PRODUKTENDRING – POCKET SKYVEDØRSKARMER

PRODUCT CHANGE – POCKET SLIDING DOOR FRAME

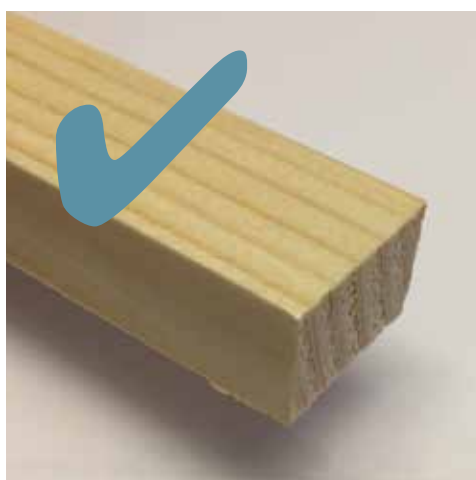
For å motvirke forskyvning av spikerslag i forbindelse med montering er spikerslagene nå uten den tradisjonelle endebearbeidingen.

Skinnelisten som spikerslaget skal slås inn i, er byttet ut med sterkere bladfjærstål som klemmer hardt rundt spikerslagene. I skinnelisten er det i tillegg en profil som holder spikerslaget fast.

På denne måten vil spikerslagene holde seg på plass hele tiden under montering/innfesting i vegg.

Denne endringen er utført og monteringsanvisning i kartongene er dessverre ikke oppdatert.

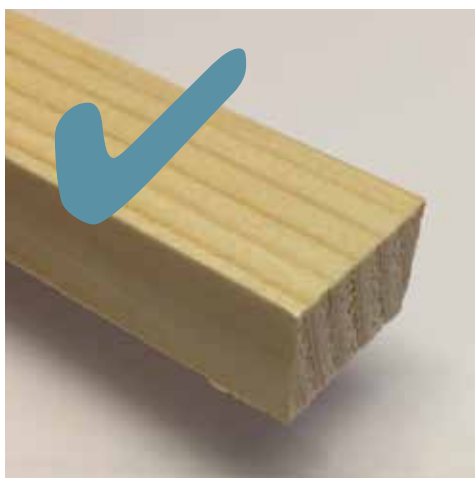
In order to avoid displacement of the nailing strips in connection with assembly, the nailing strips are now without traditional end tooling.

The rail skirting with steel profiles where the nailing strips is to be inserted into, has been replaced with stronger leaf spring steel that clamps hard around the nailing strips. In the new steel profile there is also a profile that holds the nailing strips firmly in place.

In this way, the nailing strips will stay securely in place during assembly and mounting.

This change has been made and the assembly instructions in the cartons are unfortunately not updated.
